LaSalle County Station

Volume 13:
Unit 2 CTS Markup
In CTS Order

Improved Technical Specifications

Figure 3.1.5-1

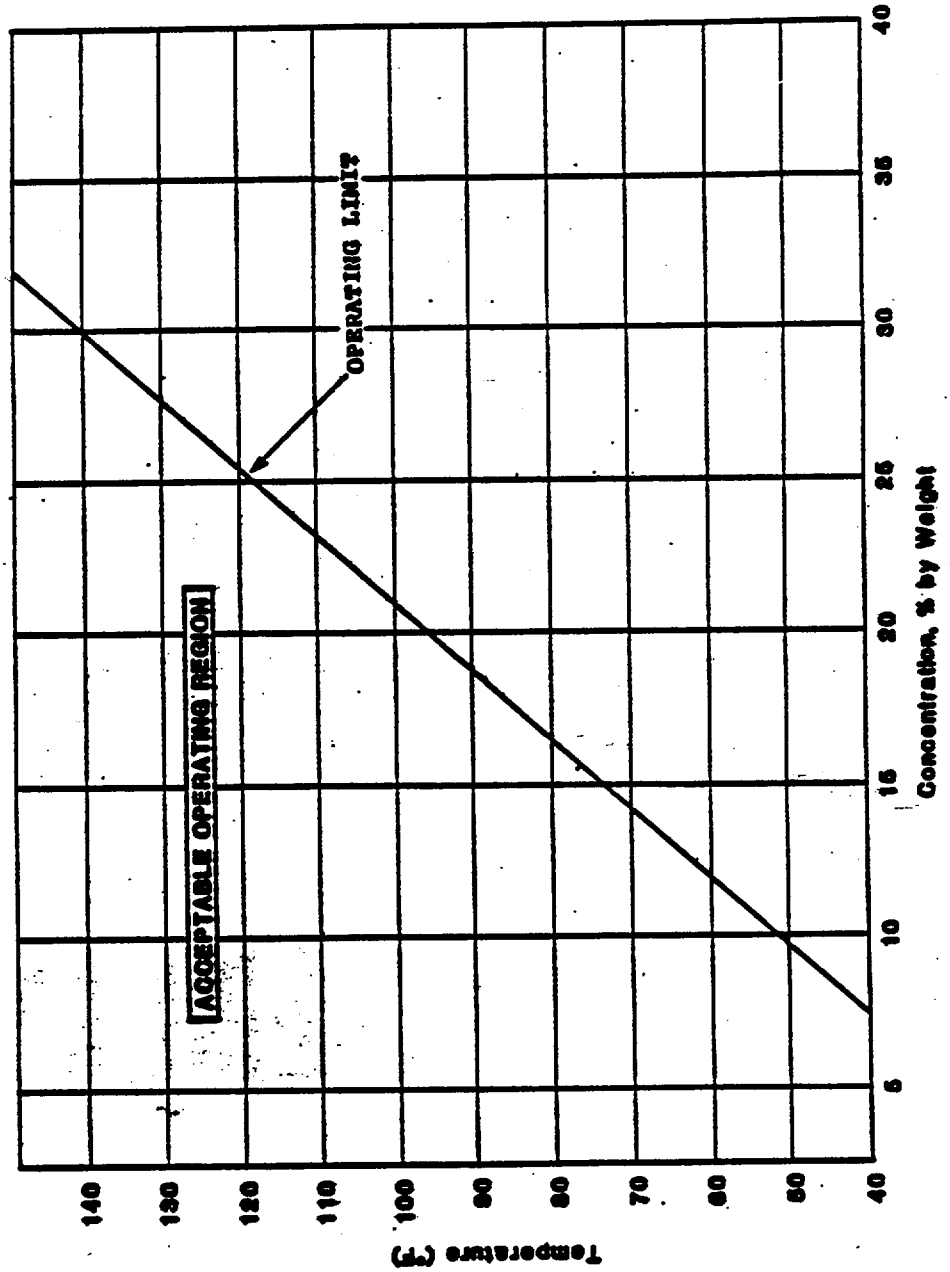
Figure 3.1.7-2

Figure 3.1.5-2

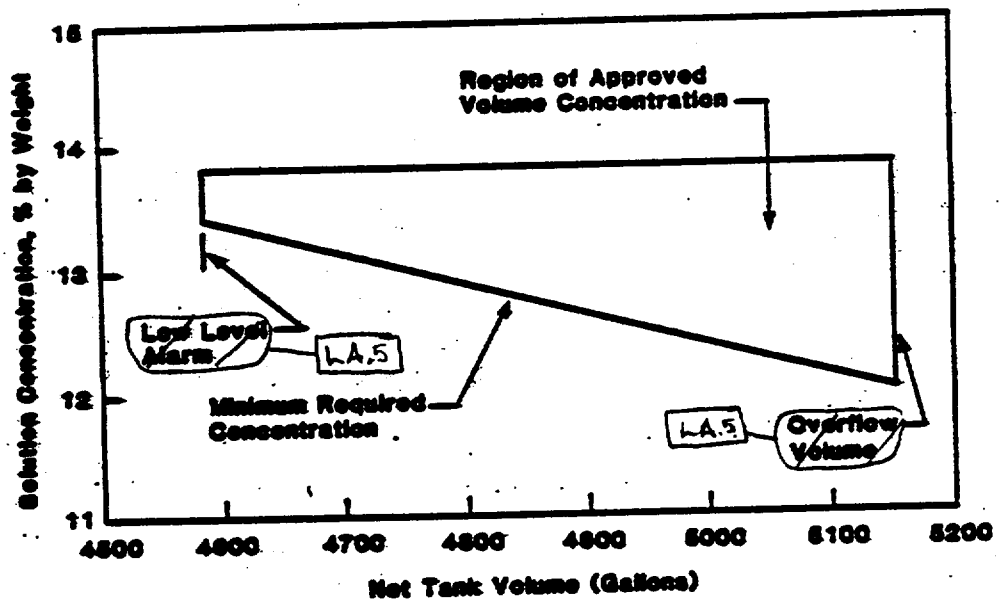
Figure 3.1.7-1

Figure 3.4.1-1 (Page 1 of 1)
Power versus Flow

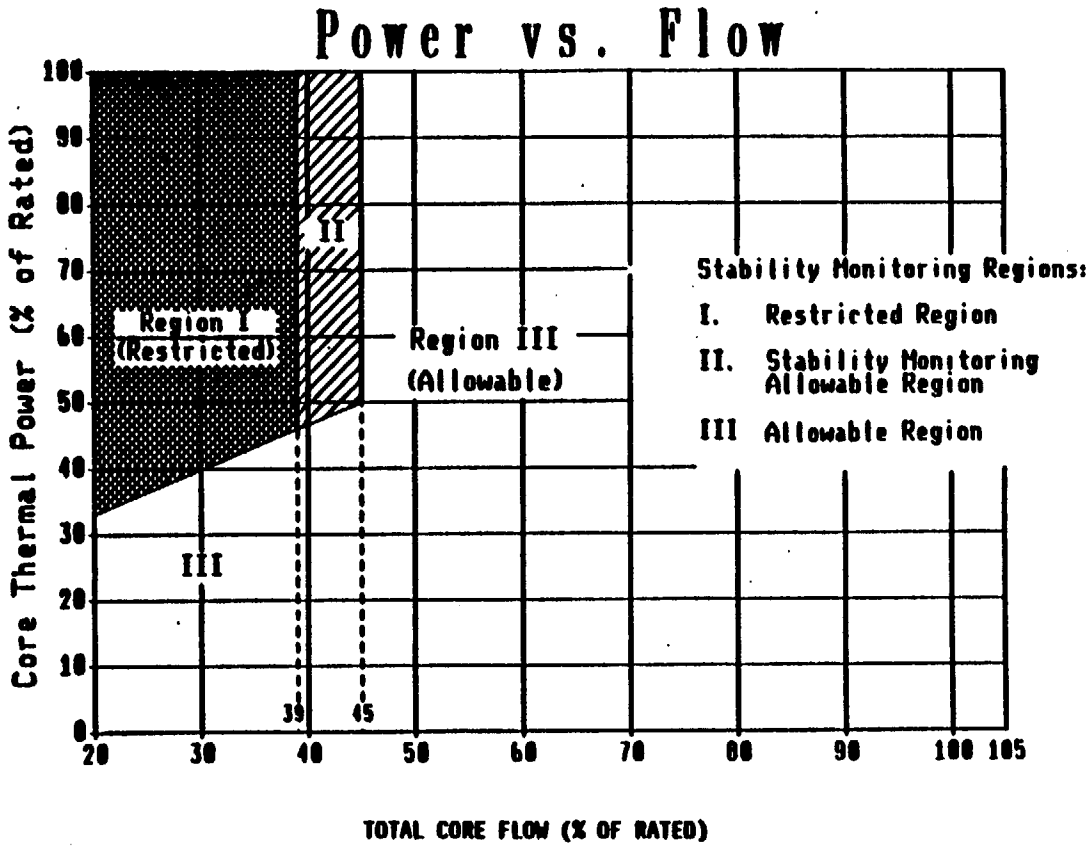
Figure 3.4.1.5-1

Figure 3.4.6.1-1a

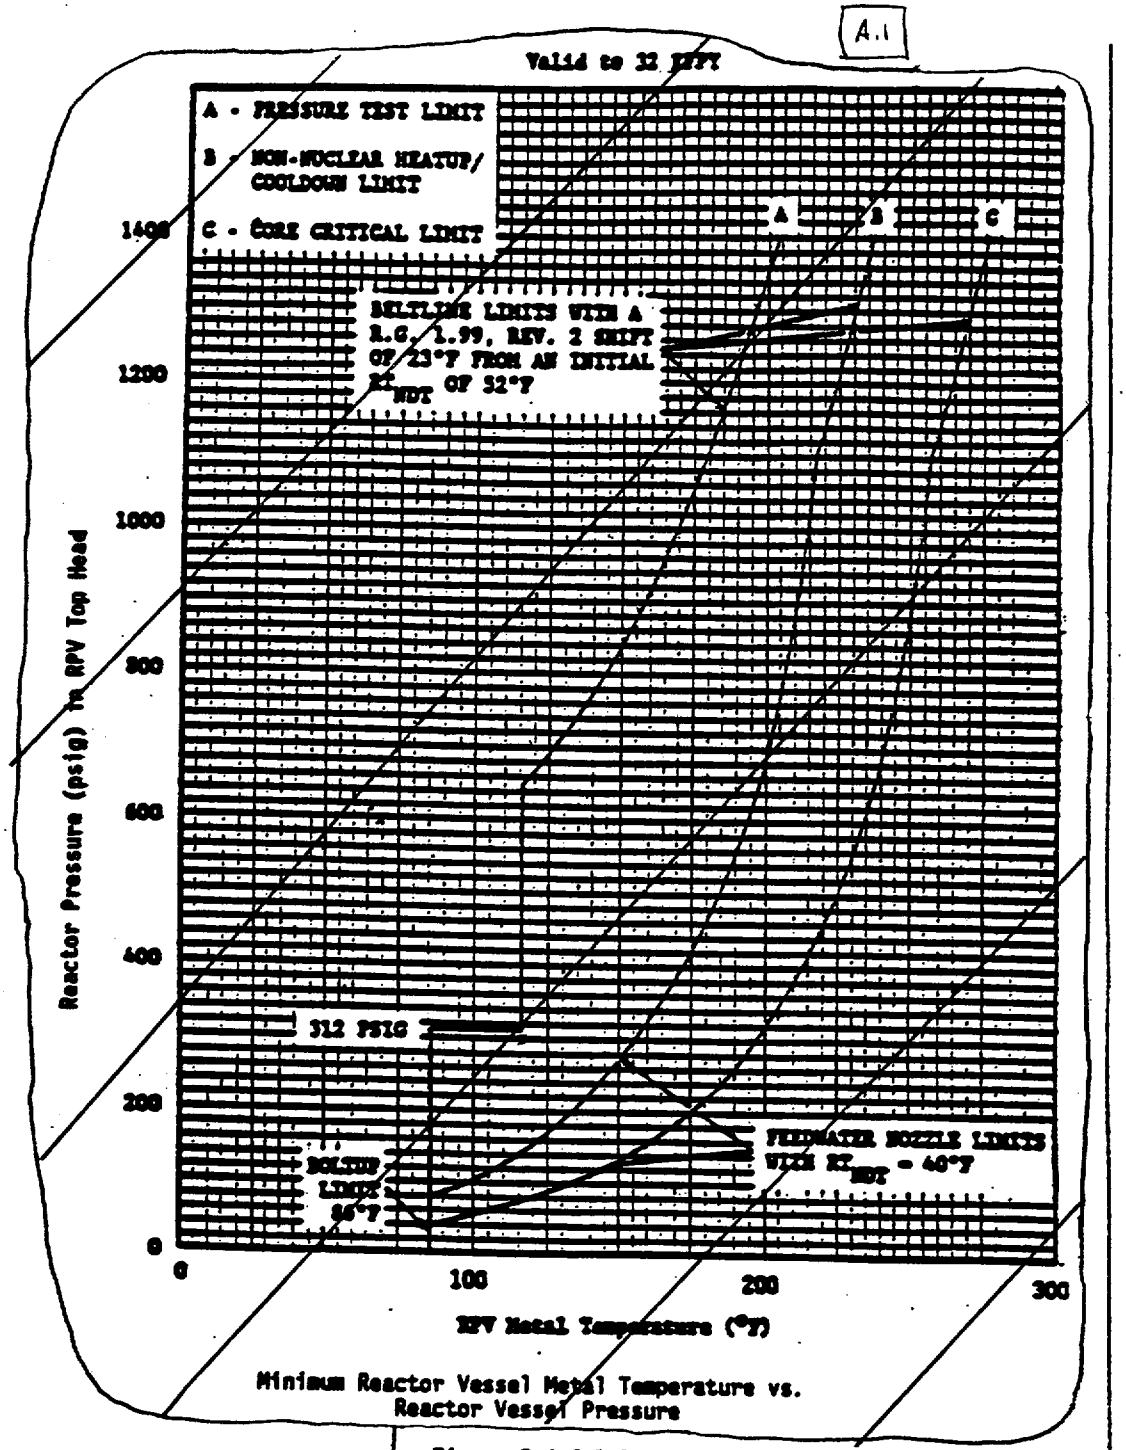
Replace with Figures 3.4.6.1-4, 3.4.6.1-5, and 3.4.6.1-6

Figure 5.1.2-1

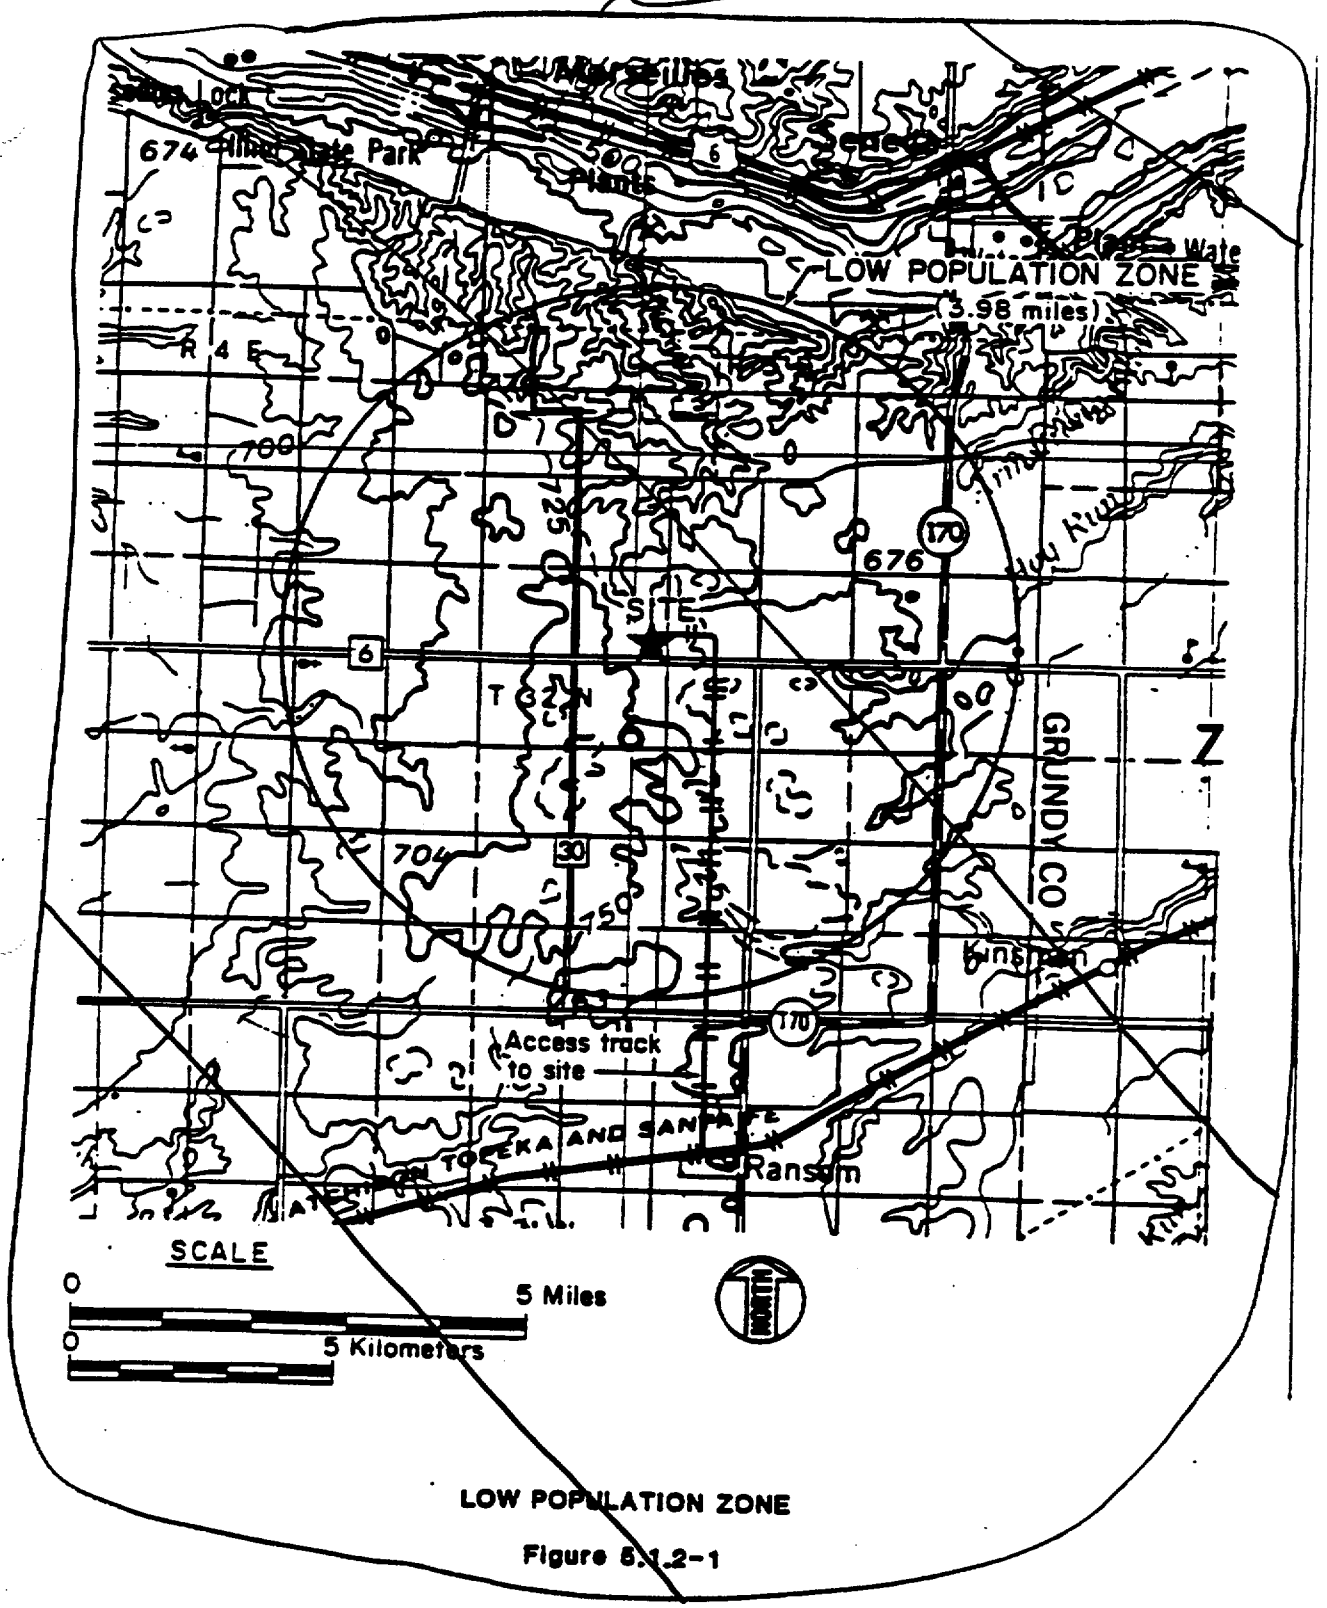
5.1.2 The low population zone shall be ~~as shown in Figure 5.1.2-1~~. all the land within a circle with its center at the vent stack and a radius of 3.98 miles
